A d d e n d u m

Iowa Department of Transportation
Office of Contracts

B.O.	Proposal ID	Proposal Work Type	County	Project Number	Addendum
356	00-000S-560	Dynamic Message Signs	Statewide	ITS-000-S(560)--25-00	19jun356.a01

Make the following change to the Plan Sheet A.1:

LATEST REVISION DATE	APPROVED BY BRIDGE ENGINEER	Iowa Department of Transportation *Highway Division*	
		STANDARD DESIGN STEEL OVERHEAD SIGN TRUSS SEPTEMBER, 2011	
		SUPPORT POST BASE AND DMS ELECTRICAL ACCESS DETAILS 50'-100' SPANS	MODIFIED SOST-06-11

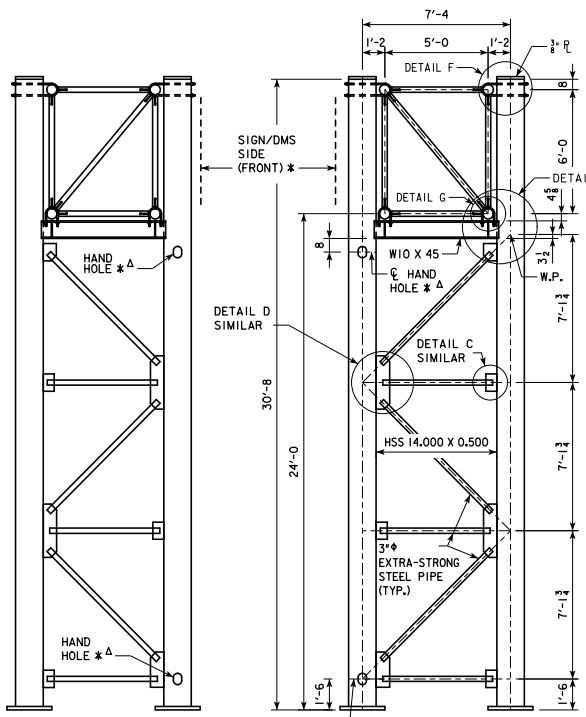
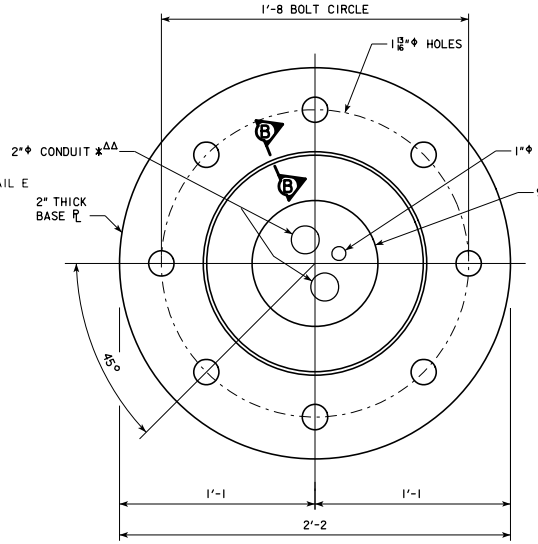
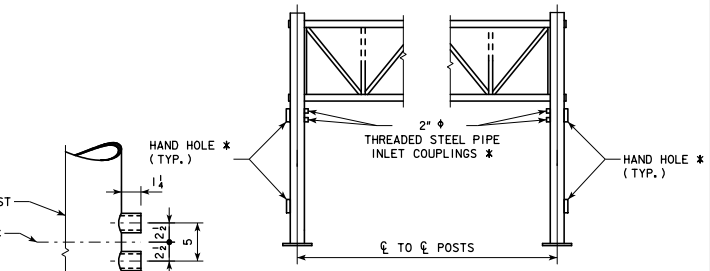
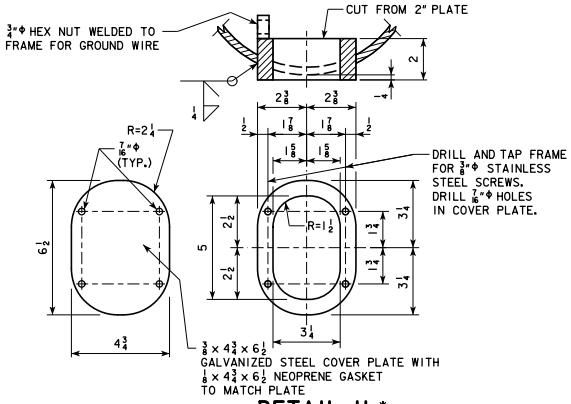
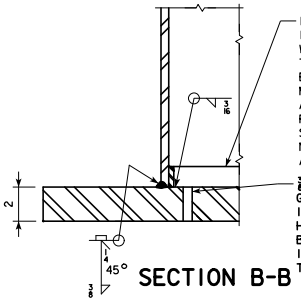
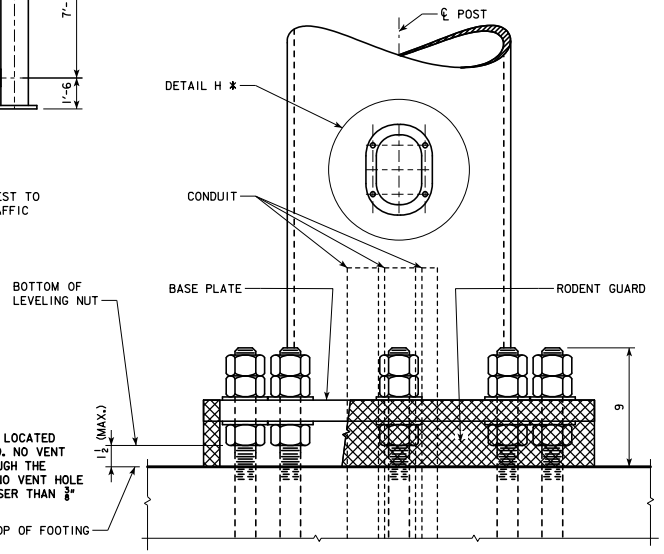
Steel Overhead Sign Truss Standard Sheet SOST-06-11
Replace SOST-06-11 with a modified SOST-06-11 sheet that includes hand hole details, electrical inlet details and conduit location information. (See attached sheet.)

ADDENDUM: ELECTRICAL DETAILS ADDED

HAND HOLES, CONDUIT, AND PIPE INLET COUPLINGS ARE TO BE INCLUDED ON DMS TRUSS DESIGNS ONLY. SEE STANDARD SHEET SOST-18-11 FOR FOOTING CONDUIT LOCATION DETAILS.

HAND HOLES AND ELECTRICAL INLET HOLES SHALL BE LOCATED IN BOTH TRUSS SUPPORTS UNLESS OTHERWISE INDICATED ON DETAIL PROJECT PLANS. LOCATE HOLES ONLY IN POSTS THAT ARE CLOSEST TO DYNAMIC MESSAGE SIGN.

THREADED STEEL PIPE INLET COUPLINGS ARE TO BE PLACED OPPOSITE TO UPPER HAND HOLE ON POST. COUPLINGS SHALL BE FITTED WITH STANDARD PLUGS UNTIL CONDUIT IS INSTALLED.

ALL CONDUIT SHALL BE SCHEDULE 40 PLASTIC.

MODIFIED
SOST-17-11

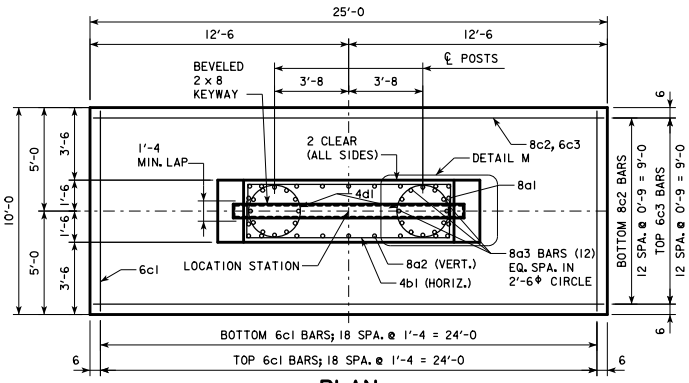
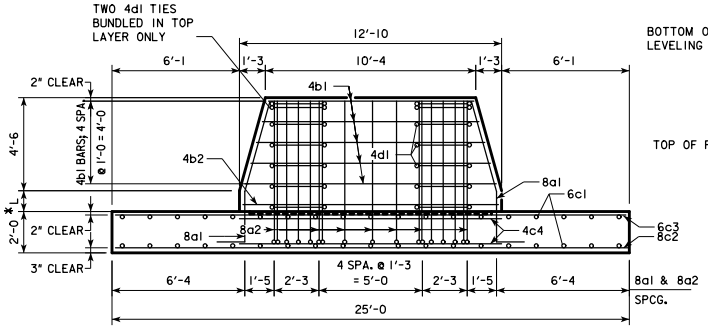
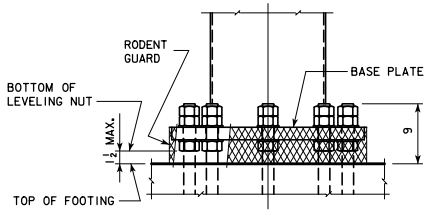
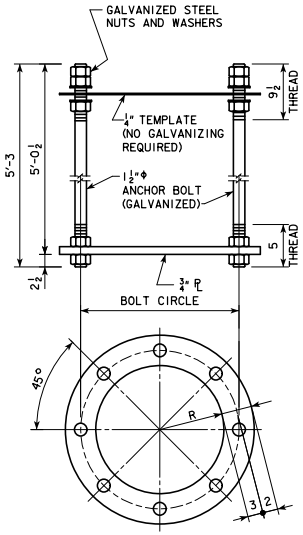
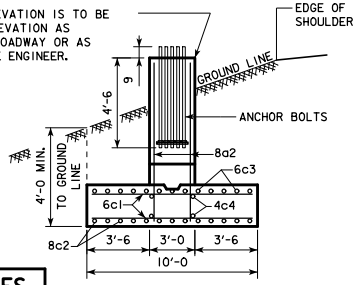
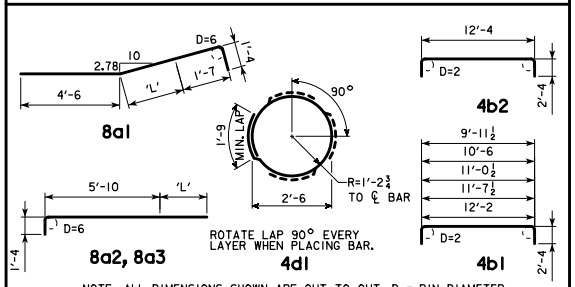
Steel Overhead Sign Truss Standard Sheet SOST-17-11
Replace SOST-17-11 with a modified SOST-17-11 sheet that includes a note stating that electrical conduit is required in footings supporting trusses with dynamic message signs. (See attached sheet.)

ADDENDUM: ELECTRICAL DETAILS ADDED

ELECTRICAL CONDUIT IS REQUIRED IN FOOTINGS SUPPORTING TRUSSES WITH DYNAMIC MESSAGE SIGNS. SEE STANDARD SHEET SOST-18-11 FOR CONDUIT LOCATION DETAILS.

SOST-18-11

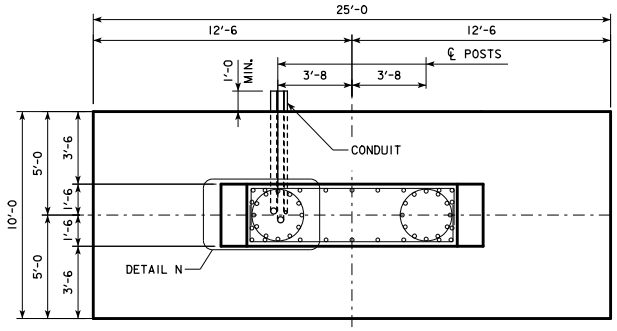
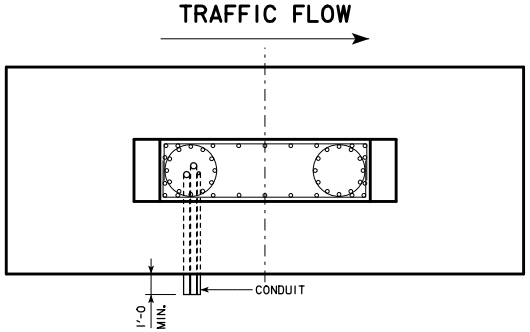
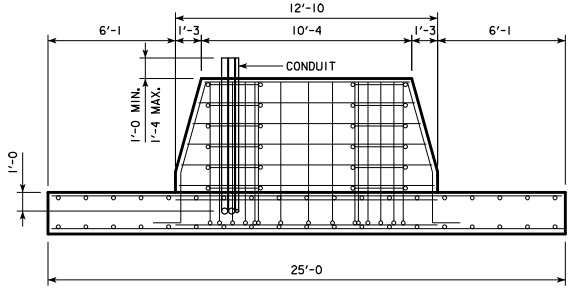
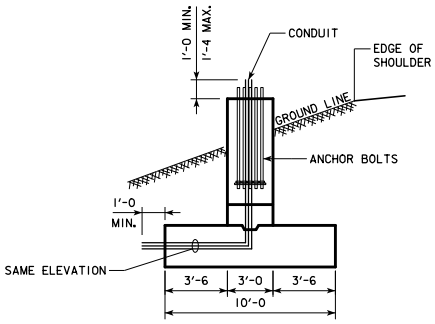
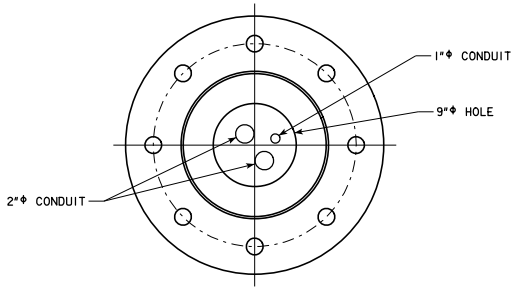
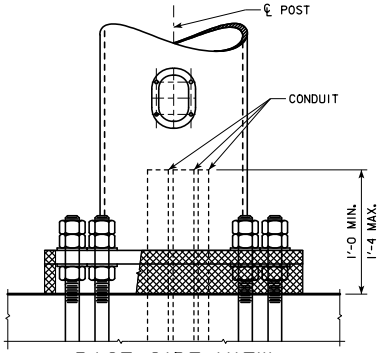
Steel Overhead Sign Truss Standard Sheet SOST-18-11
Add a new SOST-18-11 sheet that shows conduit location details in footings. (See attached sheet.)

ADDENDUM: THIS SHEET ADDED

FOR FOOTINGS SUPPORTING TRUSSES WITH DYNAMIC MESSAGE SIGNS, PLACE ONE 1"Φ CONDUIT AND TWO 2"Φ CONDUIT WITHIN THE ANCHOR BOLT CIRCLE CLOSEST TO THE DIRECTION OF THE APPROACHING TRAFFIC. EXTEND CONDUIT ENDS A MINIMUM OF 1'-0 ABOVE FOOTING WALL AND 1'-0 PAST EDGE OF FOOTING ON SIDE AWAY FROM ROADWAY. CONDUIT SHALL BE PLACED IN BOTH FOOTINGS UNLESS OTHERWISE INDICATED ON DETAIL PROJECT PLANS. ALL CONDUIT SHALL BE SCHEDULE 40 PLASTIC.
